IMPORTANT SAFETY RECALL

NHTSA Number: 25V-897 (School Bus)

SUBJECT: R26DY: Electric Vehicles May Shut Down

R26DY – Electric Vehicles May Shut Down

Figure 1

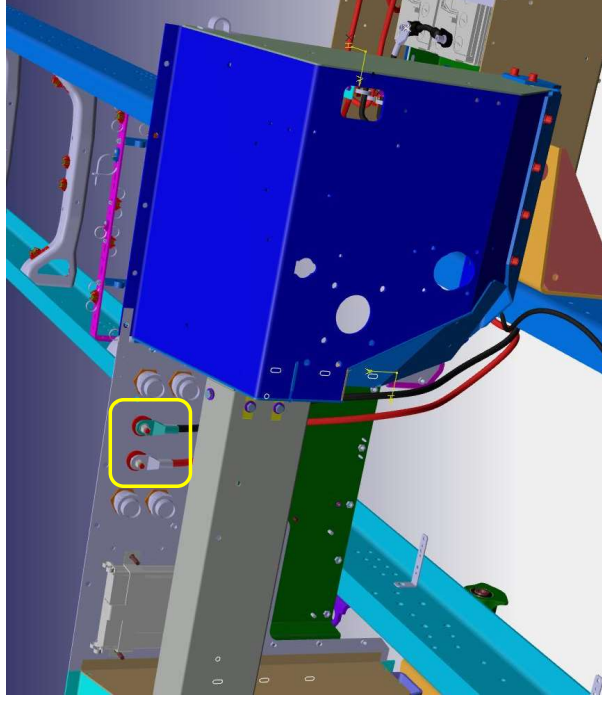
1. Remove negative battery cable from 12v Battery bank and secure.
2. Replace both positive and negative DCM pass through studs. (See Figure 1 & 2)
3. Service locations highlighted in Figures 4 - 7. Any connections/components found to have any thermal stress MUST be replaced.
4. Clean/prep connection(s) per Figure 3, and torque per legend on Page 2.

Figure 6

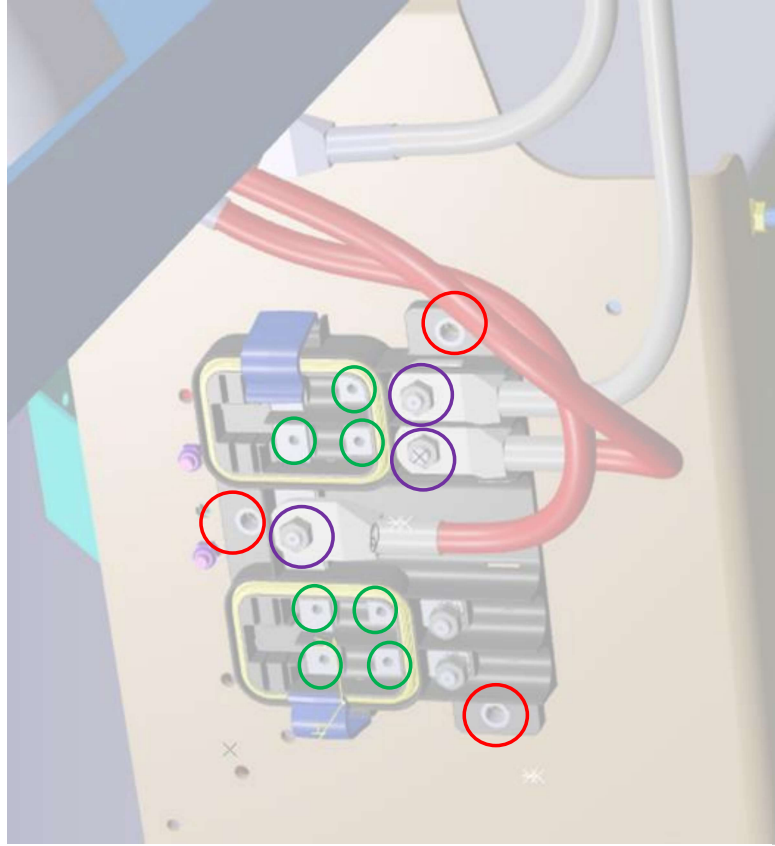
1. Remove battery negative cable and secure.
2. Remove all chassis cables from original BPDA and prep per Figure 3
3. Remove BPDA assy and install new BPDA per Figure 12
4. Torque connections on new BPDA per Figure 6

Figure 8

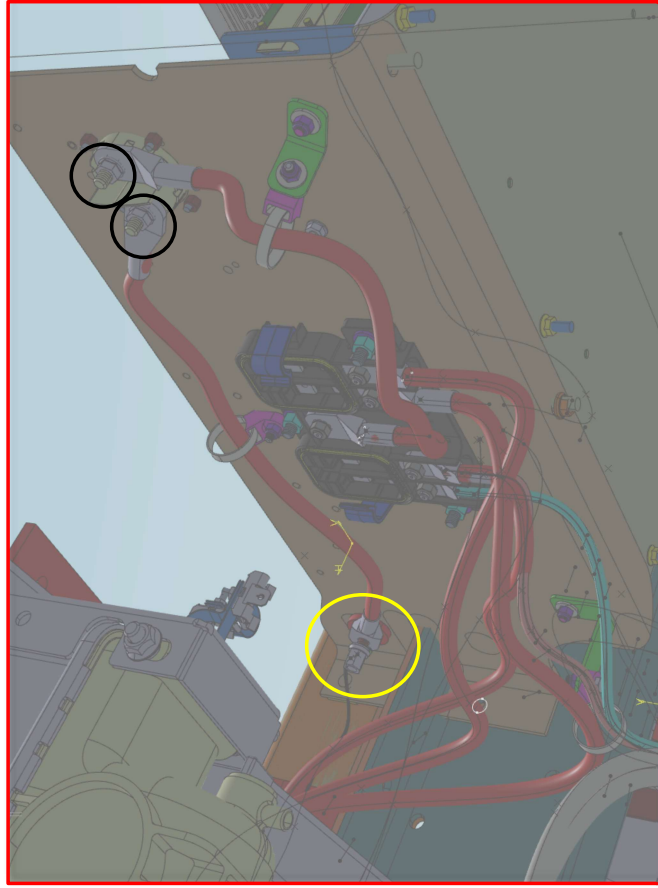
1. Remove negative battery cable from 12v Battery bank and secure.
2. Service locations highlighted in Figures 8 - 12. Any connections/components found to have any thermal stress MUST be replaced.
3. Clean/prep connection(s) per Figure 3, and torque per legend on Page 2.
